TO: Water Rights Section JUNE 7, 2001  
 FROM: Groundwater/Hydrology Section IVAN GALL / GRANTS PASS *IKB*  
 Reviewer's Name  
 SUBJECT: Application G- 15333

## WATER RESOURCES DEPARTMENT MEMORANDUM

**Date:** June 7, 2001  
**To:** Groundwater/Hydrology  
**From:** Ivan Gall – Southwest Region Hydrogeologist, Grants Pass  
**Subject:** GW Application **G-15333**

**Applicant:** Edward and Paula Savage  
**Seek:** 0.0382 CFS; 7.6 acre-feet for 3.04 acres  
**From:** Two wells, Jackson Creek sub-basin, Rogue Basin  
**Proposed Use:** Irrigation (April 1 – October 31) of landscaping  
**Quad Name:** Medford West

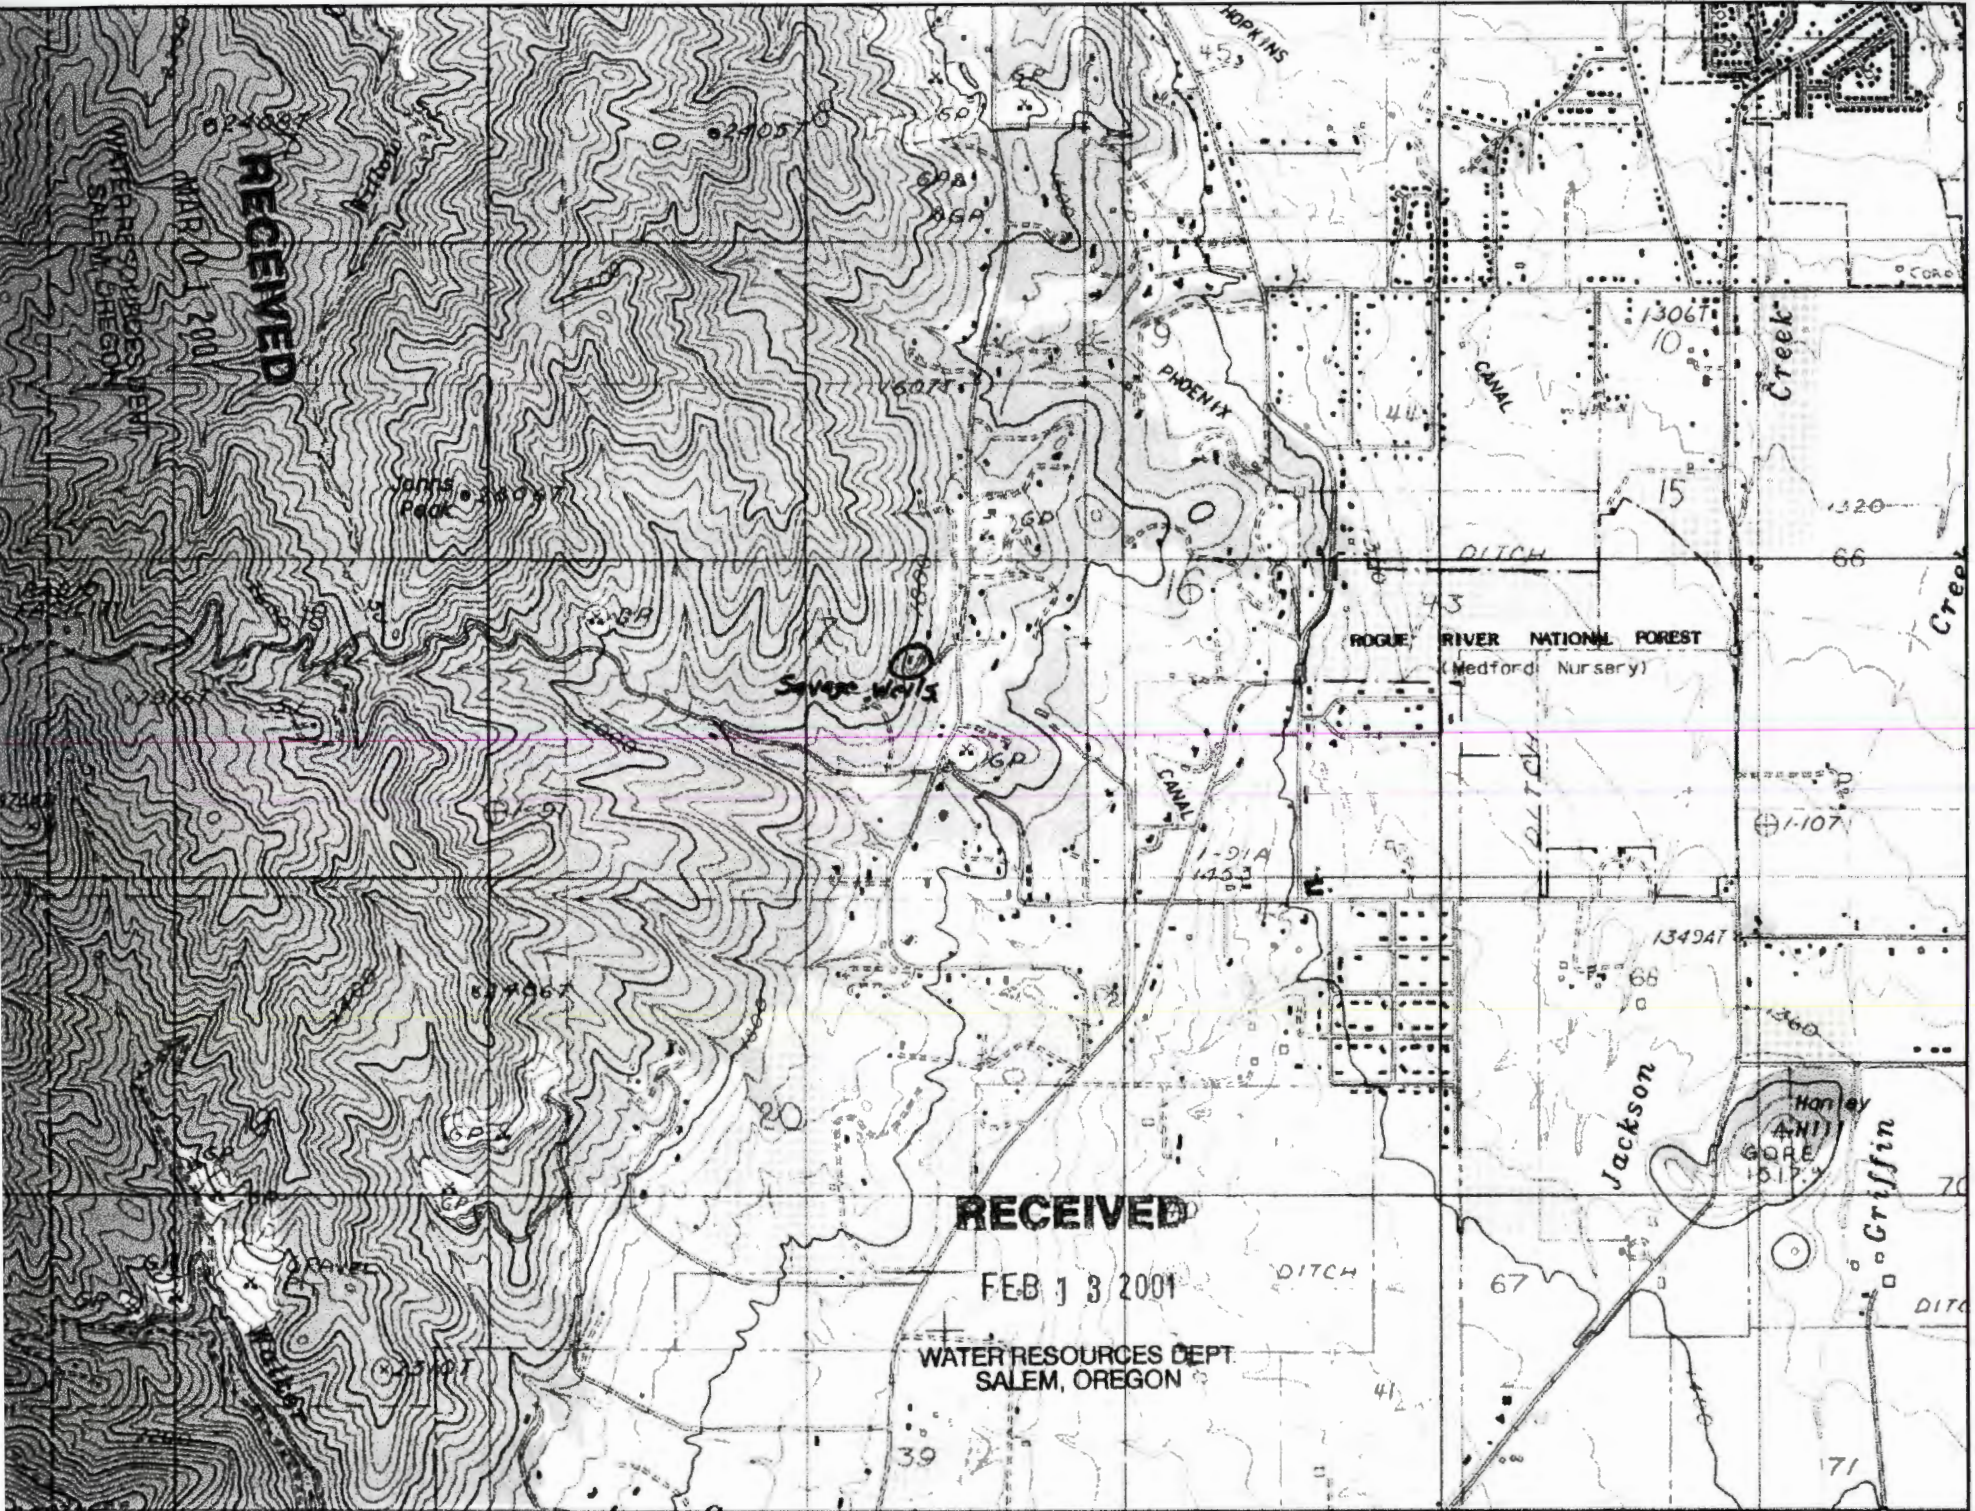
*The ground water resource appears to be available at this location to support seasonal irrigation of 3.04 acres without the potential for substantial interference with nearby users or nearby surface water. The permit should include the following conditions:*

*7B, 7F*

*Additionally, a condition shall be added to specify the two sources of appropriated ground water. For example, "Ground water shall be appropriated from only two drilled wells: Well #1 located approximately 1,825 feet west and 21 feet south of, and Well #2 located approximately 1,867 feet west and 225 feet south of, the east ¼ corner of section 17. Both Wells #1 and #2 are to be completed in the fractured bedrock aquifer. For Well #1, total well depth shall not exceed 180 feet below ground surface, and shall be cased no less than 22 feet below ground surface. For Well #2, total well depth shall not exceed 135 feet below ground surface, and shall be cased no less than 25 feet below ground surface."*
